Access Compliance Report

Public Rights-of-Way

(Curb Ramps)

Intersection ID: N/A	Main Street: BRECKFIELD_CT	Cross Street: HALKIRK_MANOR_LN	Location: SE
ADA ID: DAF266FC0763	Ramp Type: PerpDiag	Initial Pass/Fail: Fail	Overall Compliance: No
Severity Score: 21.25			
Codes/Mitigation Info/Possible Solution		Field Measurements/Component Compliance

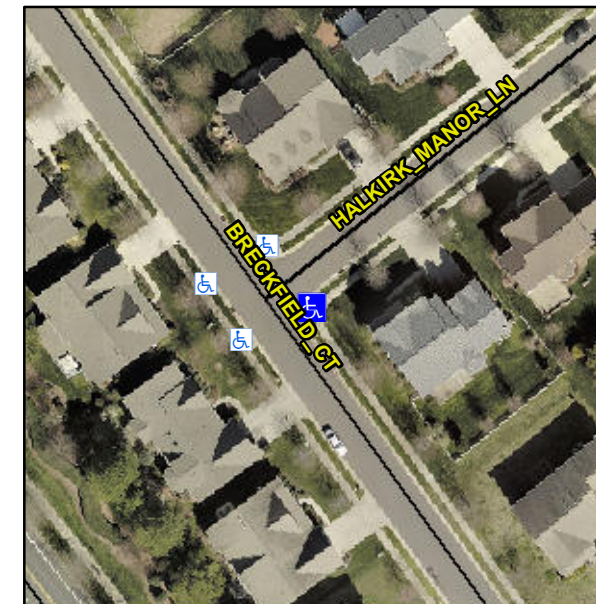
Not Found, R304.5.1, R304.2.2

Compliance	Description	Data	Compliance	Description	Data
N/A	Ramp Length (in)	49.0	No	Ramp Slope (%)	9.0
No	Ramp Width (in)	47.0	Yes	Ramp XSlope (%)	1.7
N/A	Flare Type LT	N/A	N/A	Flare Type RT	N/A
N/A	Flare Slope LT (%)	N/A	N/A	Flare Slope RT (%)	N/A
N/A	Flare Traversable LT?	N/A	N/A	Flare Traversable RT?	N/A
N/A	Landing Length (in)	N/A	N/A	DWS Provided?	N/A
N/A	Landing Width (in)	N/A	N/A	DWS Contrast?	N/A
N/A	Landing Slope (%)	N/A	N/A	DWS Length (in)	N/A
N/A	Landing X Slope (%)	N/A	N/A	DWS Full Width?	N/A
N/A	Landing Curb? (Y/N)	N/A	N/A	DWS Offset (in)	N/A
N/A	Shared Landing?	N/A			
N/A	Gutter Ponding?	N/A	N/A	Gutter Slope (%)	N/A
N/A	Gutter Lip Ht (in)	N/A	N/A	Gutter X Slope (%)	N/A
N/A	Painted X Walk1?	No	N/A	Painted X Walk2?	No
	X Walk 1 Direction	To NW		X Walk 2 Direction	To SW
N/A	X Walk 1 Width (in)	N/A	N/A	X Walk 2 Width (in)	N/A
	X Walk 1 Slope (%)	1.6		X Walk 2 Slope (%)	3.3
	X Walk 1 X Slope (%)	3.4		X Walk 2 X Slope (%)	1.4

Remove & Replace Curb Ramp With Two New Directional Ramps or Equivalent.
